C.V.A., L.L.C. SUBDIVISION

APPLICATION NUMBER 1 DATE November 2, 2006

REQUEST Subdivision

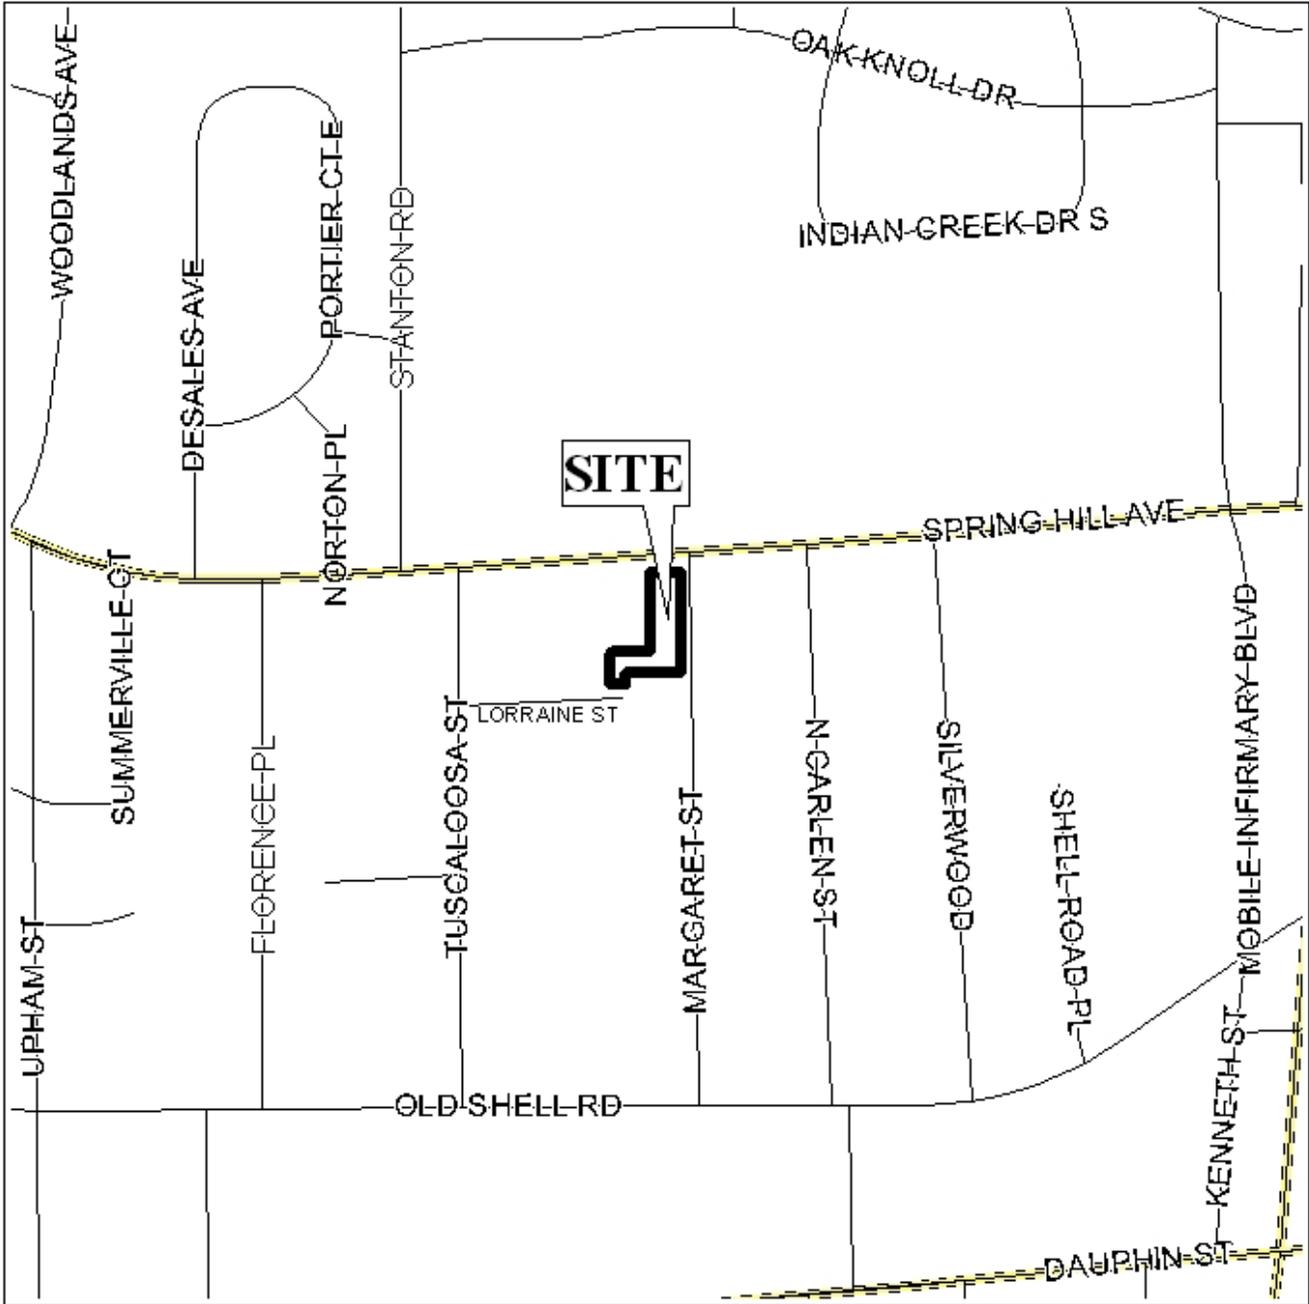
The plat illustrates the proposed one-lot, 0.7± acre subdivision which is located at the Southwest corner of Spring Hill Avenue and Margaret Street, extending to the North side of Lorraine Street at its East terminus. Spring Hill Avenue has the required 100-foot major street right-of-way, and Margaret and Lorraine Streets both have the required 50-foot rights-of-way. The subdivision is served by public water and sanitary facilities. The building setback lines are not shown but would be required on the final plat, showing 25 feet from Spring Hill Avenue and 20 feet from Margaret Street.

The purpose of this application is to create a one-lot subdivision from three tax parcels, which are comprised of portions of lots of record that have been divided without subdivision approval. As these have changed hands multiple times since the unauthorized division, the adjoining property owners cannot be required to participate.

It should be noted that the parcel at the Southwestern part of the site exists as the result of an unauthorized division of Lot 16 of the "J. D. Lyon Subdivision" in 1982, which has isolated the remainder of that lot with only a 12-foot wide access to Lorraine Street (although fortunately it is under the same ownership as two other parcels fronting Spring Hill Avenue). This flag-lot and substandard access situation are highly undesirable in this urban and commercial setting, and the ideal arrangement would altogether omit this parcel from the present subdivision application, and leave the possibility of its future recombination with the remainder of Lot 16. However, it is not possible now to require that. Nevertheless, as a means of access management, the new lot should be denied direct access to Lorraine Street, since it currently has access to both Spring Hill Avenue and Margaret Street.

In other respects the plat would meet the minimum standards of the Subdivision Regulations, and is recommended for Tentative Approval, subject to the following conditions: 1) the placement of a note on the final plat stating that the site is denied direct access to Lorraine Street; and 2) the placement of the building setback lines on the final plat, showing 25 feet from Spring Hill Avenue and 20 feet from Margaret Street.
